HISTORIC AND DESIGN REVIEW COMMISSION

August 03, 2022

HDRC CASE NO: 2022-398
ADDRESS: 418 VILLITA ST
LEGAL DESCRIPTION: NCB 130 ALL OF BLK
ZONING: D, H, RIO-3
CITY COUNCIL DIST.: 1
DISTRICT: La Villita Historic District
LANDMARK: Individual Landmark
APPLICANT: Mark Navarro/Fisher Heck Architects
OWNER: CITY OF SAN ANTONIO
TYPE OF WORK: Construction of a commercial structure, construction of an addition to the Faville House
APPLICATION RECEIVED: July 15, 2022
60-DAY REVIEW: Not applicable due to City Council Emergency Orders
CASE MANAGER: Edward Hall
REQUEST:

The applicant is requesting conceptual approval to:

FAVILLE RESTAURANT - SOUTH ELEVATION

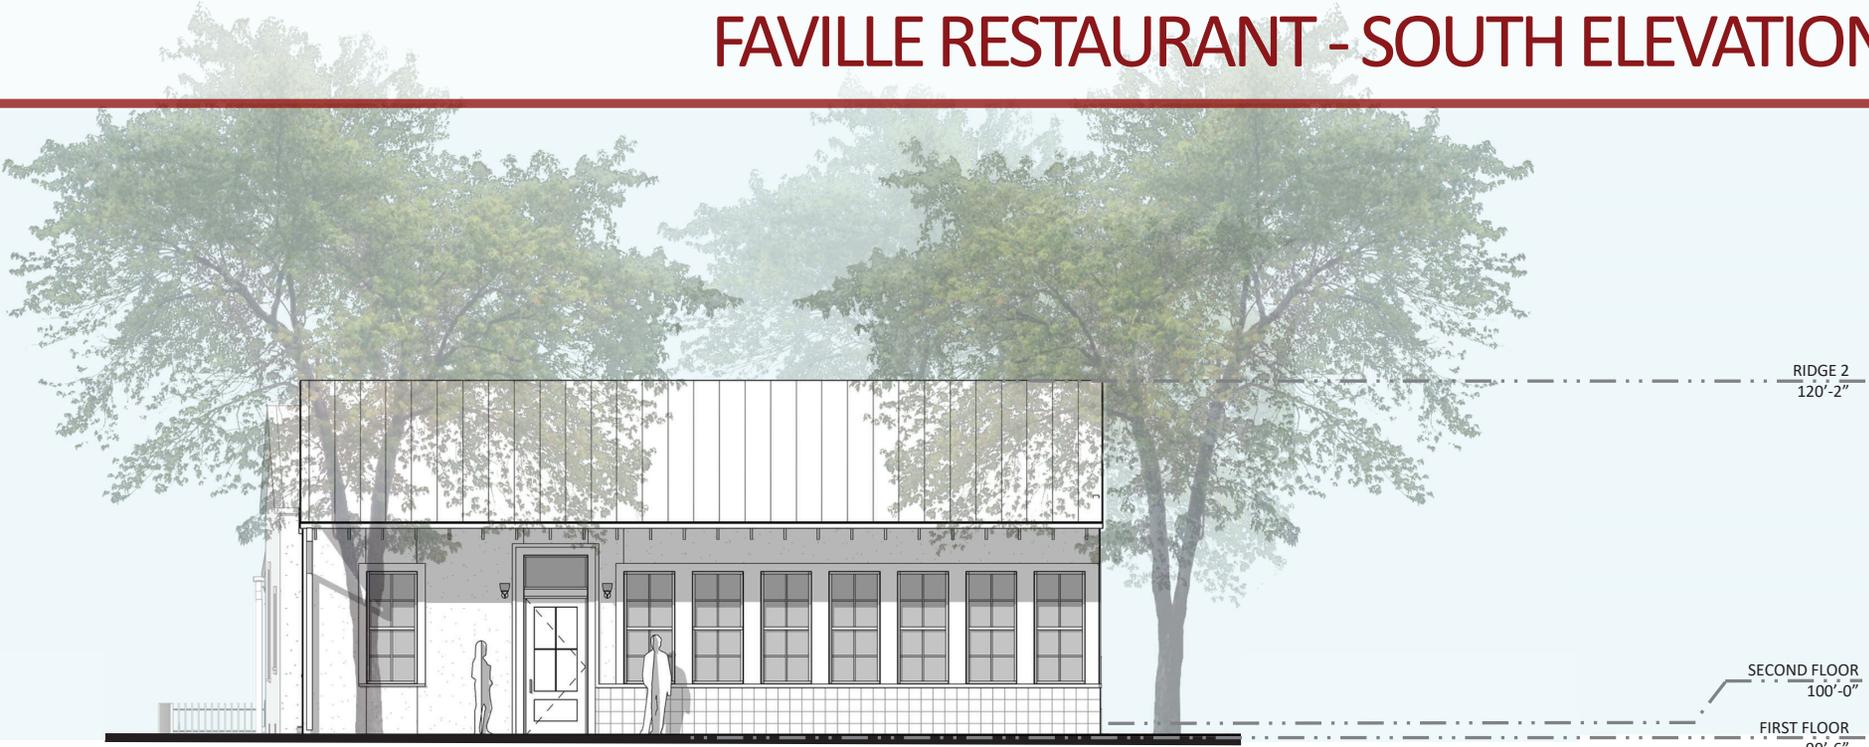
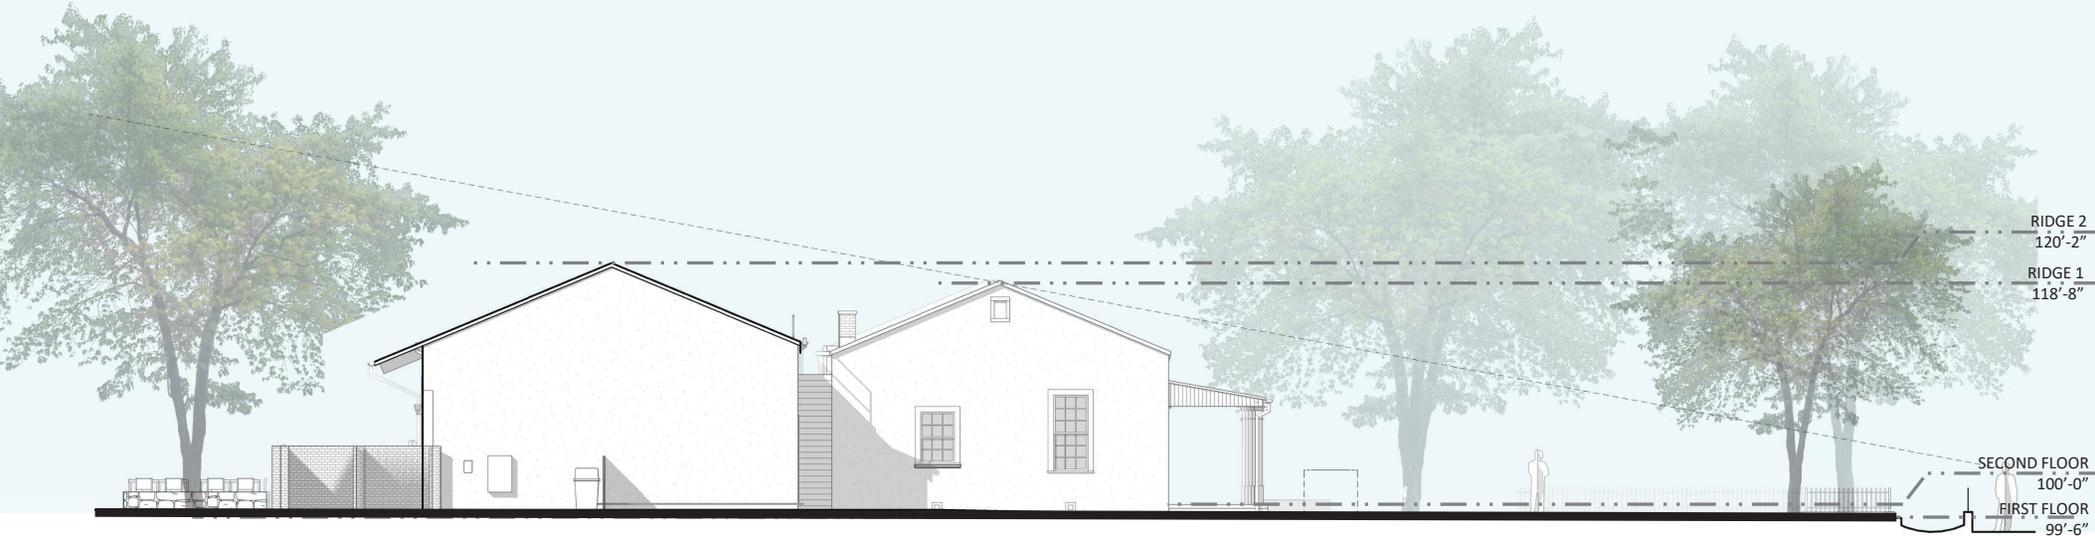
- 2e. MATERIALS – The applicant has proposed for the rear addition to feature a plaster finish, a standing seam metal roof, wood windows and Spanish tile mosaics. Generally, staff finds the proposed materials to be appropriate; however, staff finds that the standing seam metal roof should feature panels that are 18 to 21 inches

wide, seams that are 1 to 2 inches in height, a crimped ridge seam and a standard galvalume finish. All roofing panels should feature a smooth finish with no corrugation or striations.

- 2f. WINDOW MATERIALS – The applicant has proposed wood windows. Staff finds the use of wood windows to be appropriate; however, the proposed windows should be consistent with staff's standards for windows in additions and new construction.
- 2g. ARCHITECTURAL DETAILS – The applicant has proposed for the rear addition to feature an overall massing and form that is generally comparable to that of the historic structure; however, the applicant has proposed for both side facades to be void of fenestration. This is neither consistent with the Guidelines nor the historic examples found within the La Villita Historic District. Staff finds that fenestration should be added to both side facades.

- iii. That the applicant provide documentation on how the proposed addition will be attached to the historic structure.
 - iv. That the applicant study the separation of the proposed addition completely from the massing of the historic structure.
